TSG-RAN Meeting #9
Hawaii, US, 20 - 22 September 2000

TSGRP#9(00)0396

Title: **Agreed CRs to TS 25.104**

Source: **TSG-RAN WG4**

Illustrative diagram of spectrum emission mask

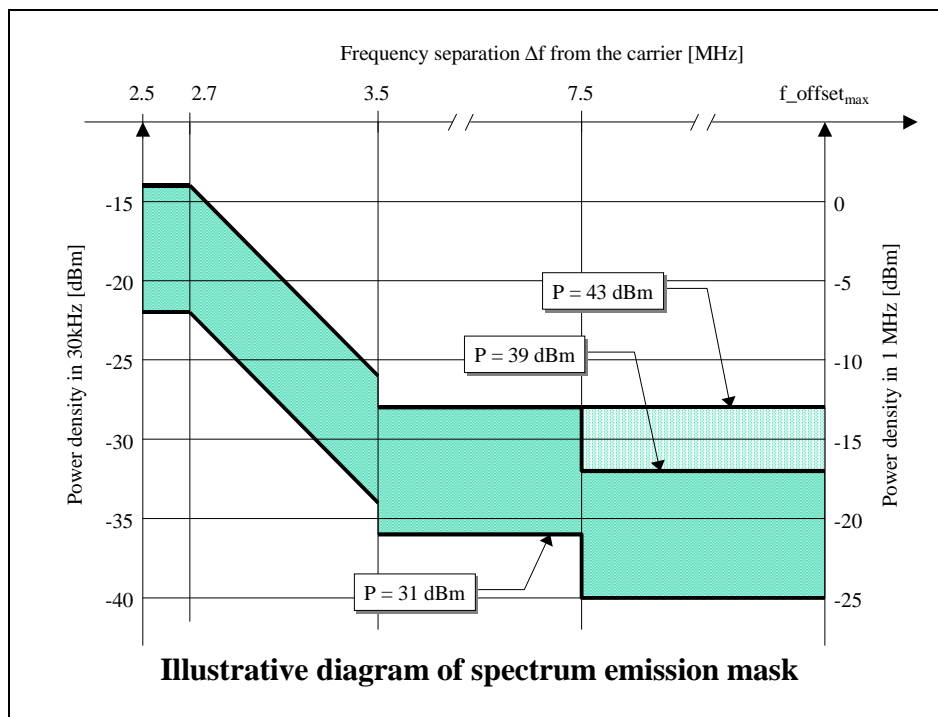
Reason for change:	The level of the spectrum mask for the frequency range [3.515, 4.0MHz[is incorrect for low power base station (discontinuity with the previous frequency range)

NOTE: This frequency range ensures that the range of values of f_offset is continuous.

Figure B.2: Birth death propagation sequence

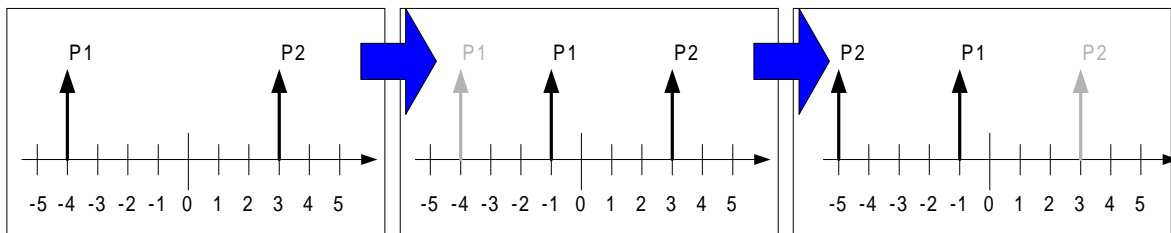
Subject:	Tap magnitudes and phases for Birth-Death propagation conditions

Reason for change:	Finalise propagation conditions for the FDD mode.

NOTE 1: Two paths, Path1 and Path2 are randomly selected from the group [-5, -4, -3, -2, -1, 0 ,1, 2, 3, 4, 5] μs. The paths have equal magnitudes strengths and equal phases.

NOTE 2: After 191 ms, Path1 vanishes and reappears immediately at a new location randomly selected from the group [-5, -4, -3, -2, -1, 0 ,1, 2, 3, 4, 5] μs but excludes the point Path2. The magnitudes and the phases of the tap coefficients of Path 1 and Path 2 shall remain unaltered.

NOTE 3: After an additional 191 ms, Path2 vanishes and reappears immediately at a new location randomly selected from the group [-5, -4, -3, -2, -1, 0 ,1, 2, 3, 4, 5] μs but excludes the point Path1. The magnitudes and the phases of the tap coefficients of Path 1 and Path 2 shall remain unaltered.
